ADDENDUM NO. 1

RFB#8517 LDLD Road Rehabilitation Project

SACRAMENTO AREA SEWER DISTRICT
 ECHOWATER RESOURCE RECOVERY FACILITY
 LDLD ROAD REHABILITATION PROJECT

GENERAL
 SURVEY MONUMENT DATA

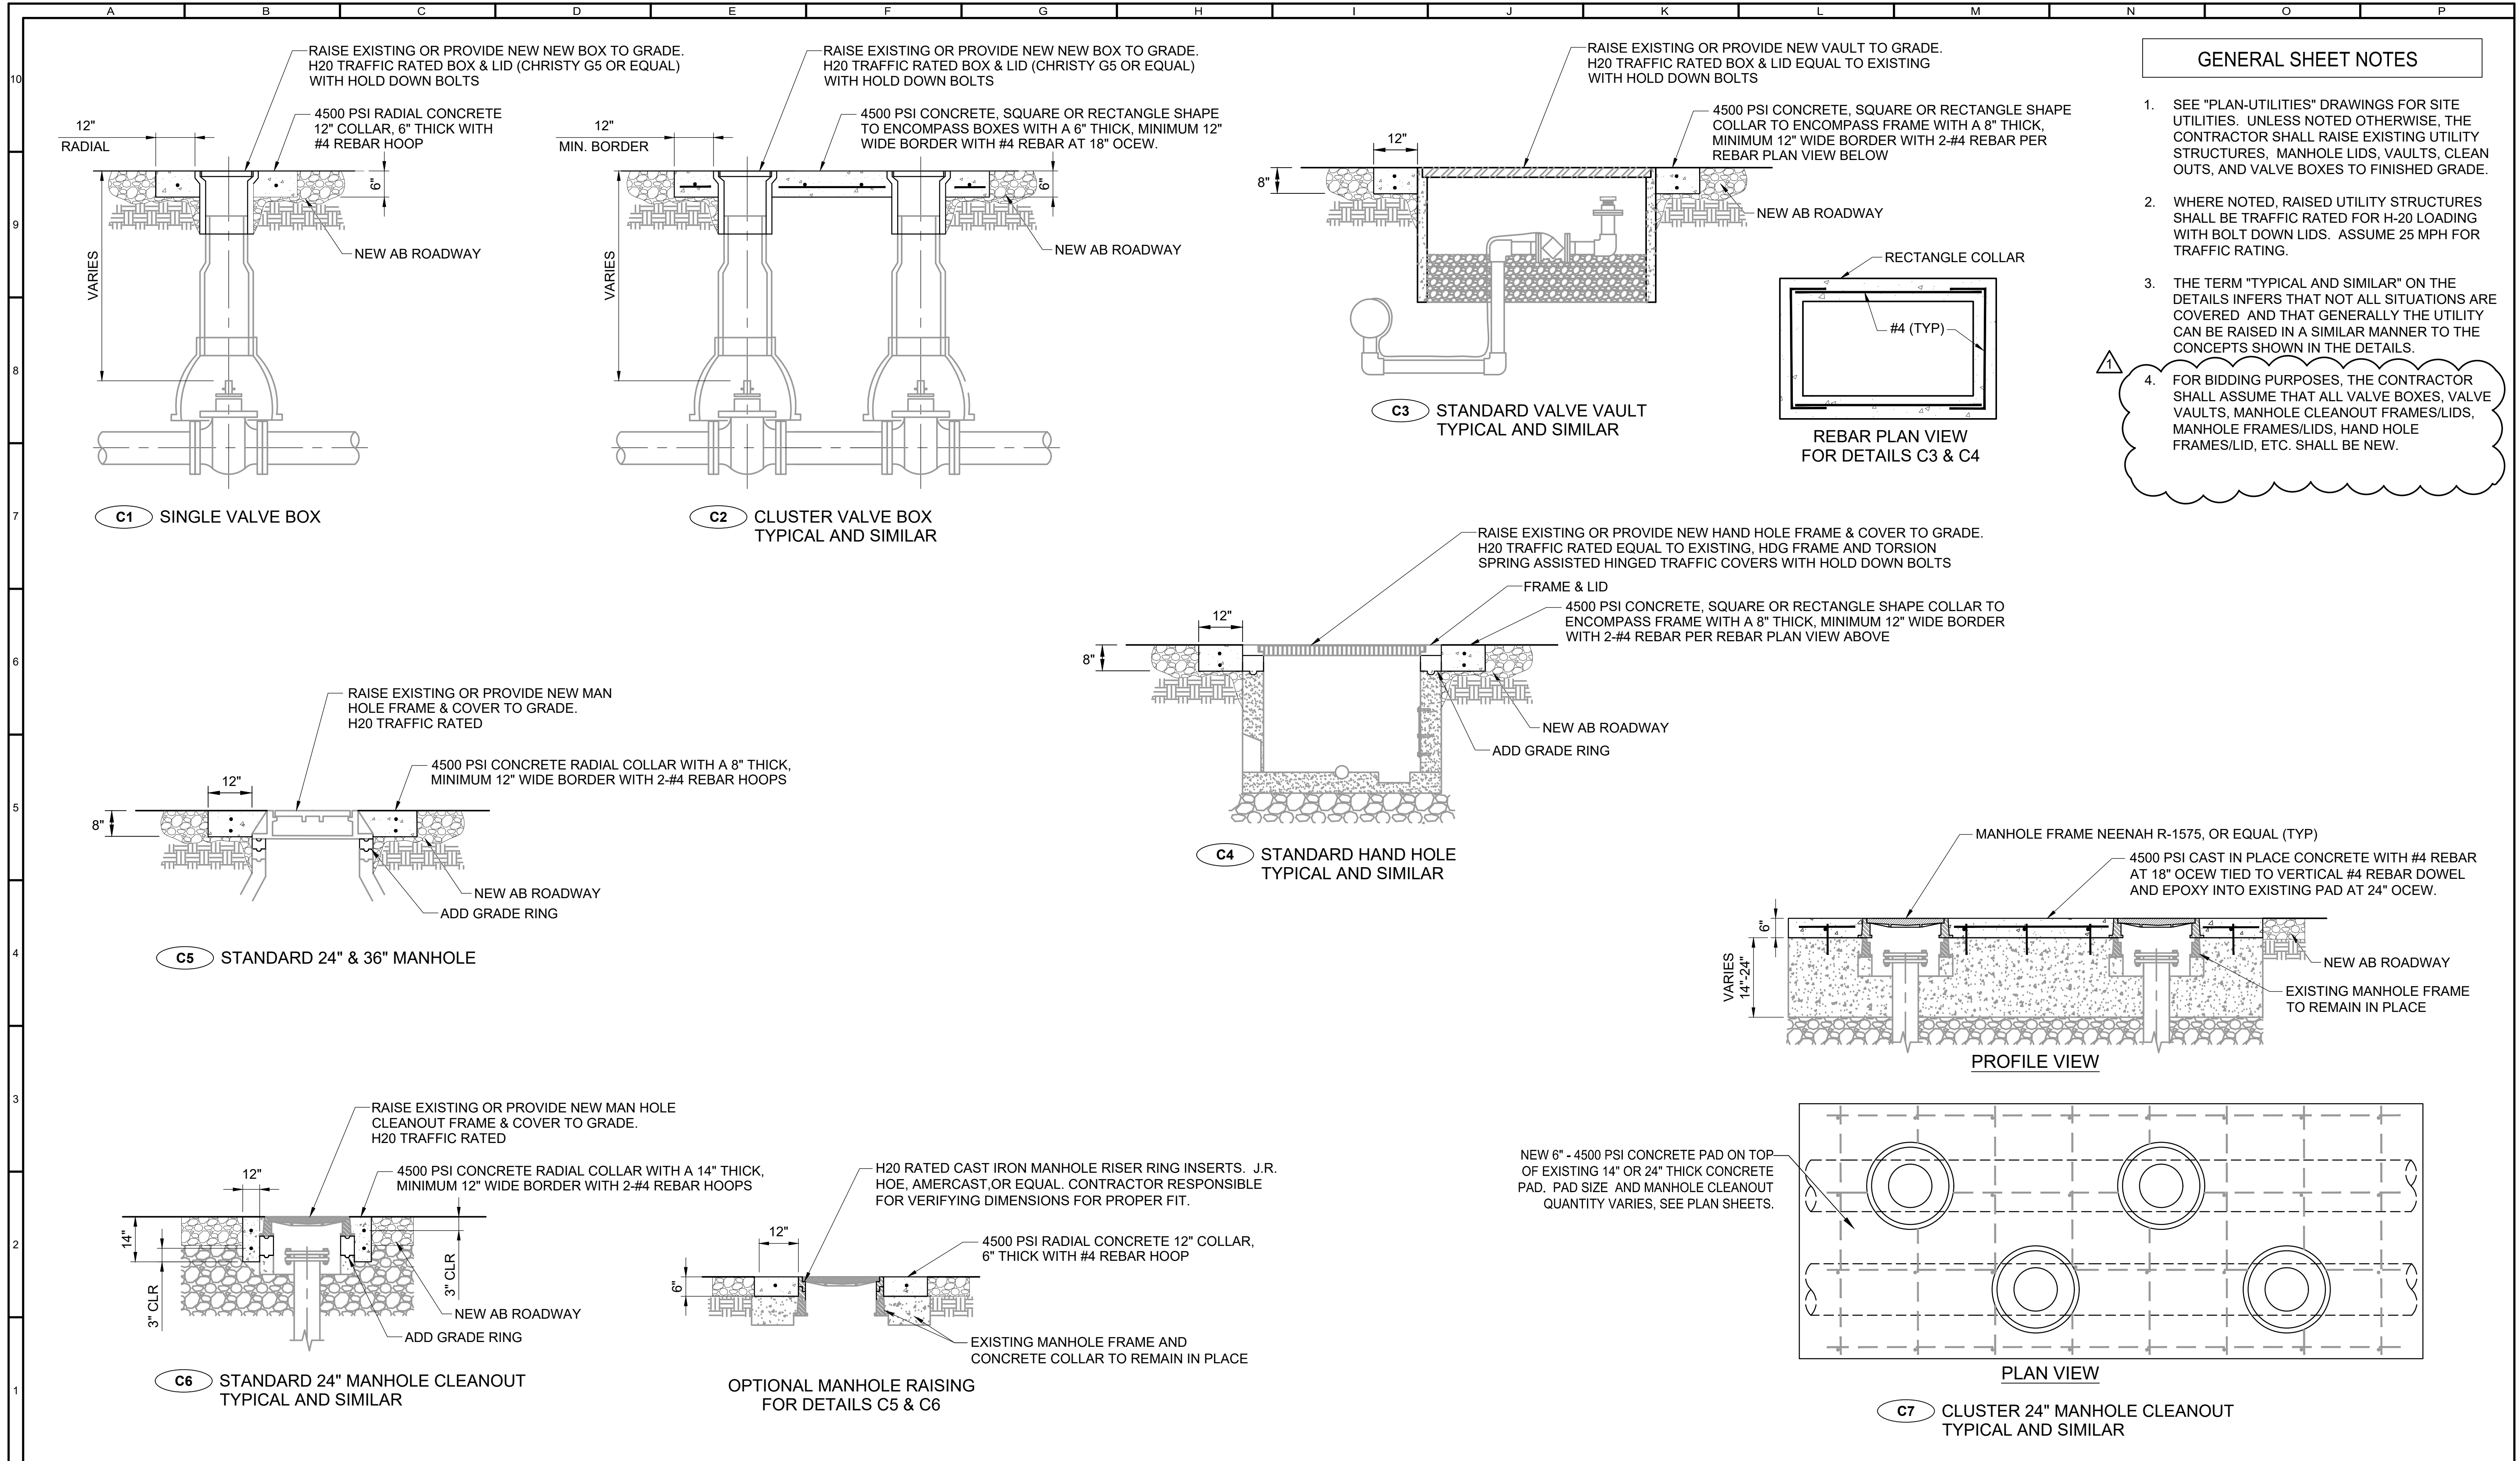
Addendum Item	Section and Page or Drawing No.	Location and Description of Change
1.01	Volume 2 of 2 Drawing GI002	ADD Drawing GI002 SURVEY MONUMENT DATA with attached Addendum 1 drawing dated 10/20/25 to the drawing set. This drawing includes survey requirements and project information.
1.02	Volume 2 of 2 Drawing C-501	REPLACE Drawing C-501 DETAILS with attached Addendum 1 drawing dated 10/20/25.

5. Who is responsible for the survey on the project? County Standards indicate the owner is responsible.

6. Are there any finish grade requirements to be met to determine if any grading needs to be performed prior to FDR treatment or placing the aggregate base?

See General Survey Note 1. on Addendum item 1.01.

See General Survey Note 2. on addendum item 1.01.

- GENERAL SURVEY NOTES:**
- DELETE SECTION 5-9.01 "AGENCY-FURNISHED SURVEYS" OF THE SACRAMENTO COUNTY STANDARD CONSTRUCTION SPECIFICATIONS. THE CONTRACTOR IS RESPONSIBLE FOR PERFORMING ALL NECESSARY SURVEYS TO LAYOUT AND CONTROL THE WORK.

- ROADWAY LINE AND GRADE SHOULD GENERALLY MIMIC THE EXISTING ROADWAY CONDITIONS, EXCEPT THAT THE NEW FDR SECTION SHALL BE CONSTRUCTED TO MATCH THE TYPICAL SECTIONS SHOWN ON DRAWING C-301. A FIXED ELEVATION IS NOT REQUIRED, BUT THE FINISHED SUBGRADE ELEVATIONS SHALL BE SIMILAR TO THE EXISTING CONDITION (+/-0.2'). THE CONTRACTOR WILL BE RESPONSIBLE FOR UTILIZING BEST EQUIPMENT GRADING PRACTICES TO PRODUCE SMOOTH, CONSISTANT, STRAIGHT GRADES THAT WILL PRODUCE UNIFORM ROADWAY SURFACES.

- MONUMENT NUMBERS 3, L-1, 3A, 3B, 3C, 3E, 3F, AND 7 SHALL NOT BE USED.
 - CONTRACTOR SHALL ESTABLISH ADDITIONAL MONUMENTS, AS NEEDED FOR CONTROL OF CONSTRUCTION.

- ELEVATIONS SHOWN REPRESENT NGVD29 PLUS 100 FEET.
 - CONTRACTOR SHALL NOTIFY THE RESIDENT ENGINEER 48 HOURS IN ADVANCE OF REMOVING OR DESTROYING ANY SURVEY MONUMENT FOR THE PURPOSE OF REFERENCING MONUMENTS OR FOR RE-ESTABLISHING A POINT AFTER WORK IS COMPLETED.

- THIS DRAWING AND ALL OTHER DRAWINGS USE THE (CA-II) NAD 27 CALIFORNIA STATE PLANE, ZONE II COORDINATE SYSTEM. IF YOU ARE USING NAD83 OR ANY OTHER COORDINATED SYSTEM, PLEASE CONVERT AS NEEDED AND IDENTIFY WHAT SYSTEM ON THE DRAWING.

CIVIL
 DETAILS

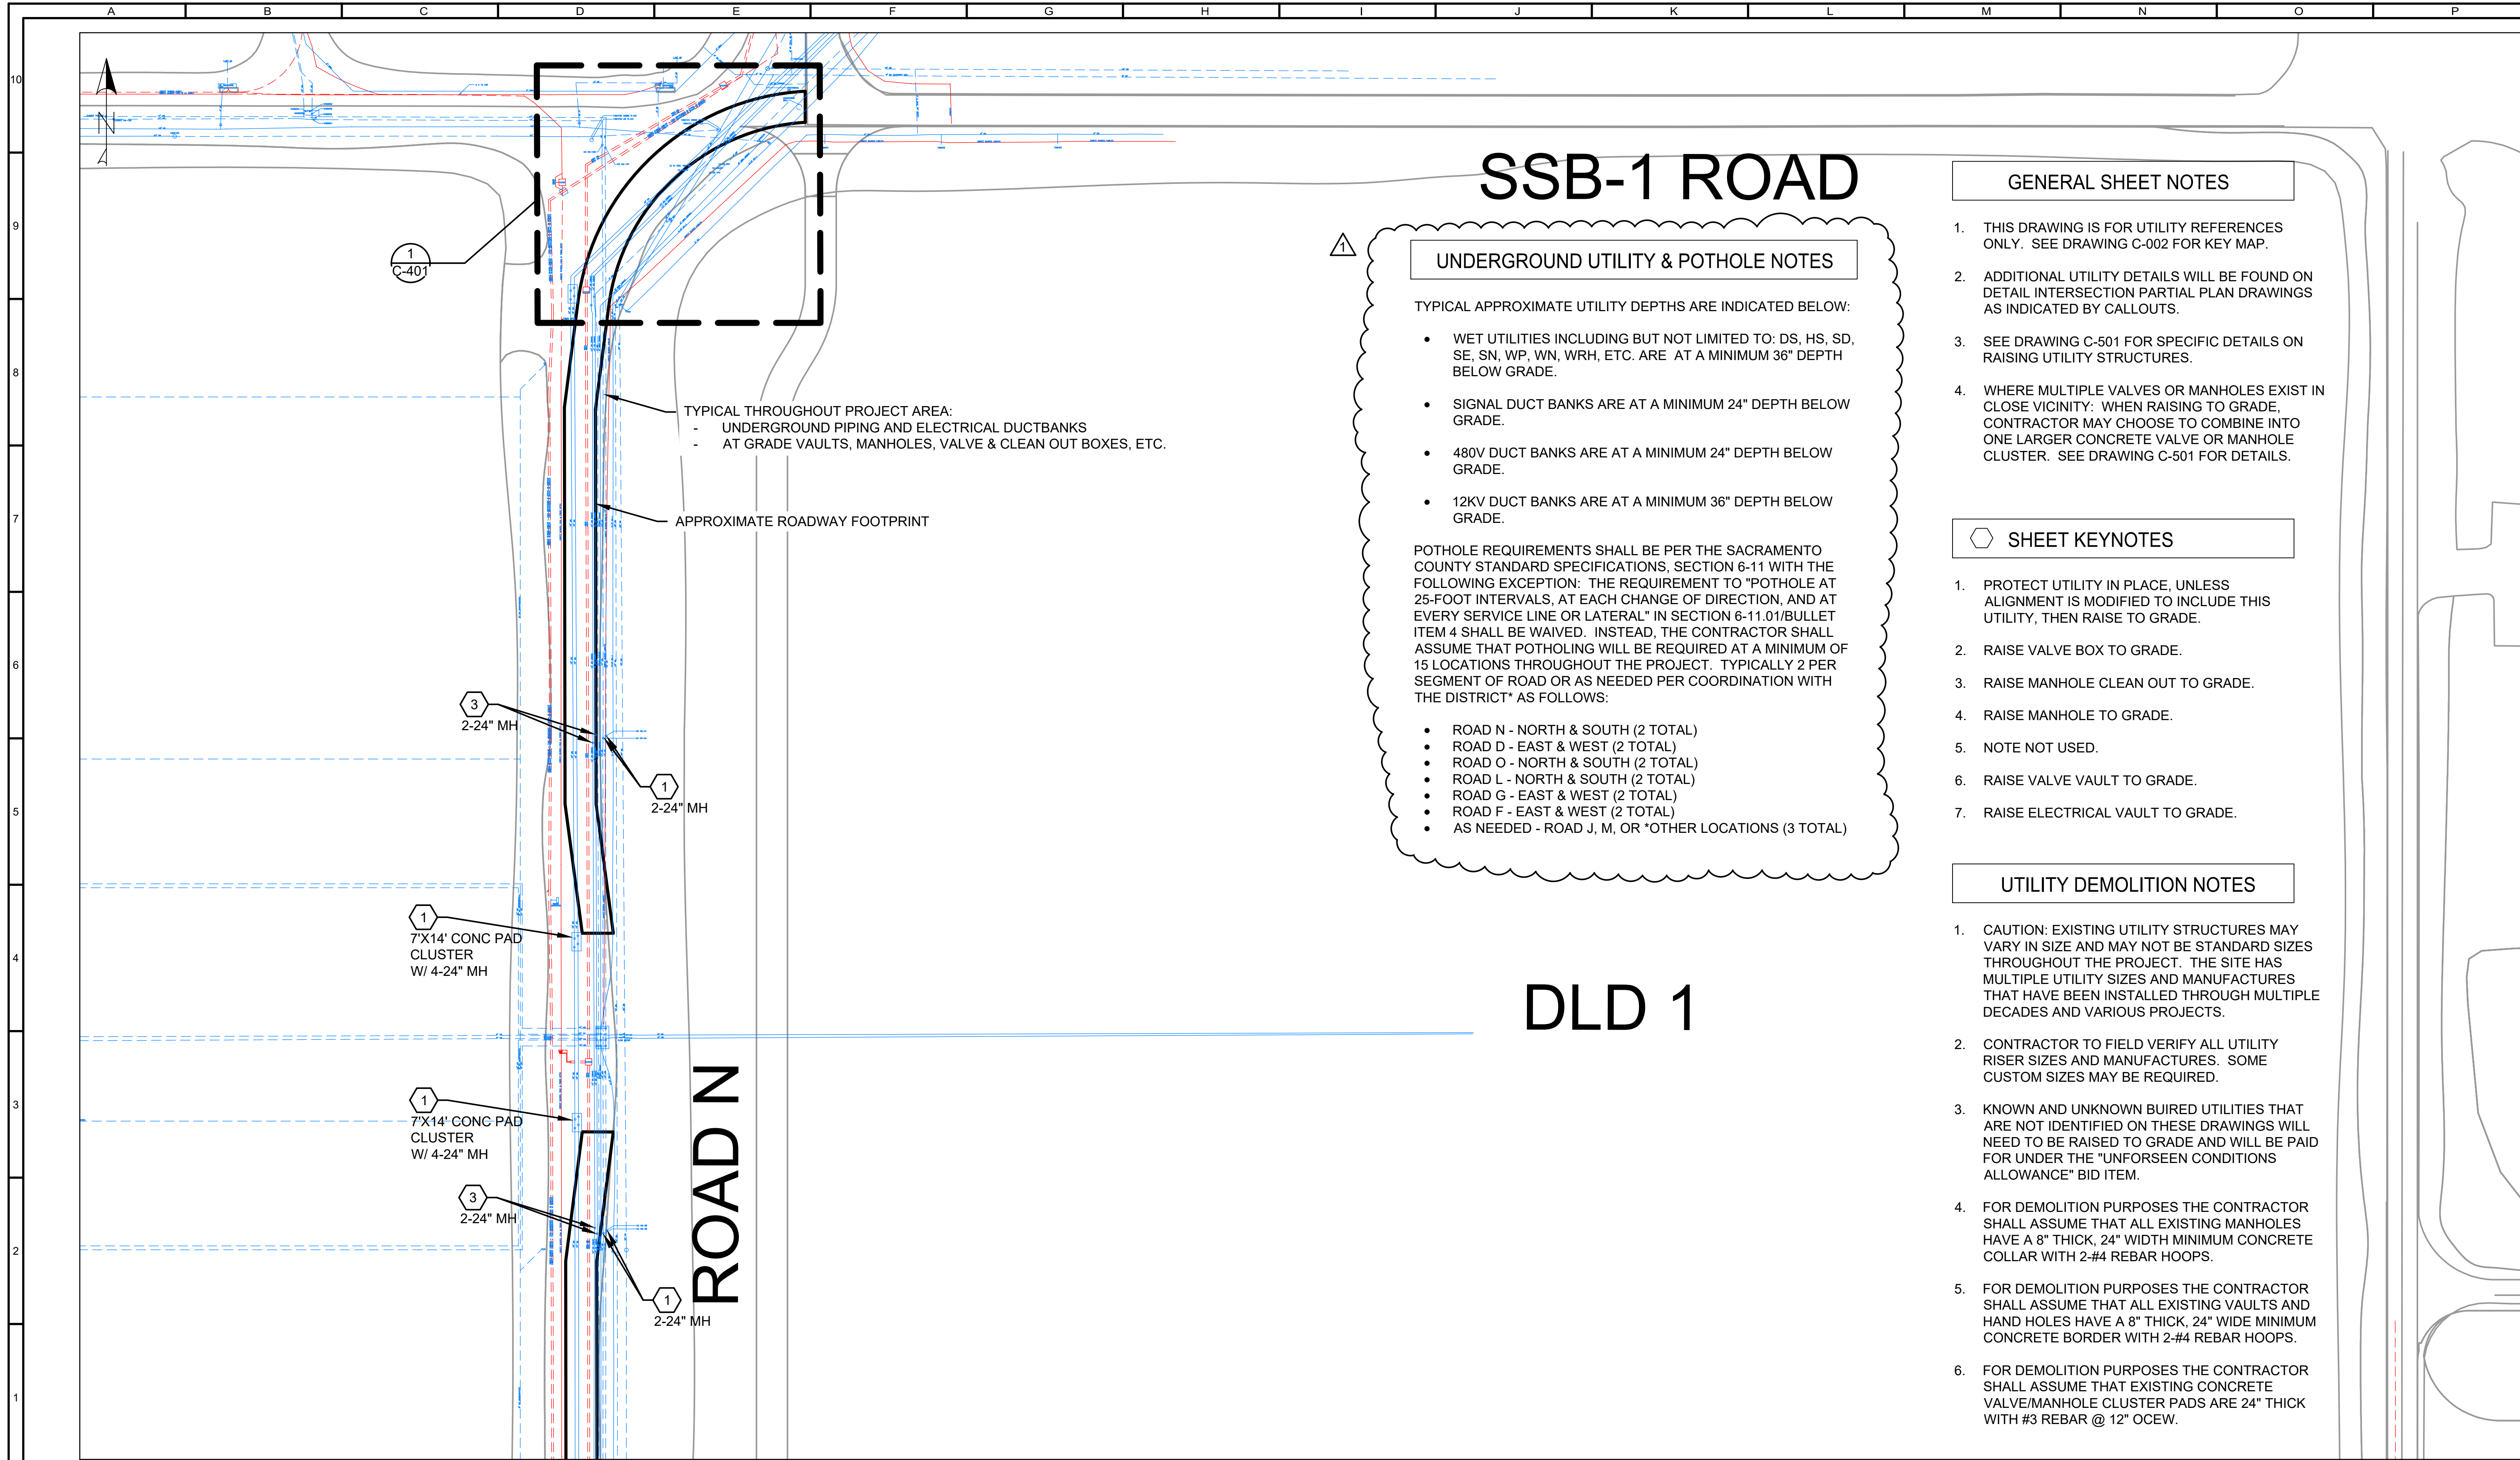
9. As brought up in the job walk, please confirm that when Sheet 5of16 says "RAISE EXISTING OR PROVIDE NEW" that we are, for bidding purposes, to provide all NEW.

10. Please confirm that Sheet 5of16 detail C4 shows that all Hand Hole boxes are to remain in place after the tops are lowered, and that we will be required to provide the following new: a precast Grade Ring, cast in place PCC Collar, and all new Frame and Cover. We are not being asked to provide new HH boxes, correct?

See General Sheet Note 4 on addendum item 1.02.

The Hand Hole boxes are to remain in place with the upper portion(Frame & Cover) being raised to grade. The contractor is not being asked to provide new Hand Hole boxes.

- SEE "PLAN-UTILITIES" DRAWINGS FOR SITE UTILITIES. UNLESS NOTED OTHERWISE, THE CONTRACTOR SHALL RAISE EXISTING UTILITY STRUCTURES, MANHOLE LIDS, VAULTS, CLEAN OUTS, AND VALVE BOXES TO FINISHED GRADE.
- WHERE NOTED, RAISED UTILITY STRUCTURES SHALL BE TRAFFIC RATED FOR H-20 LOADING WITH BOLT DOWN LIDS. ASSUME 25 MPH FOR TRAFFIC RATING.
- THE TERM "TYPICAL AND SIMILAR" ON THE DETAILS INFERS THAT NOT ALL SITUATIONS ARE COVERED AND THAT GENERALLY THE UTILITY CAN BE RAISED IN A SIMILAR MANNER TO THE CONCEPTS SHOWN IN THE DETAILS.
- FOR BIDDING PURPOSES, THE CONTRACTOR SHALL ASSUME THAT ALL VALVE BOXES, VALVE VAULTS, MANHOLE CLEANOUT FRAMES/LIDS, MANHOLE FRAMES/LIDS, HAND HOLE FRAMES/LID, ETC. SHALL BE NEW.
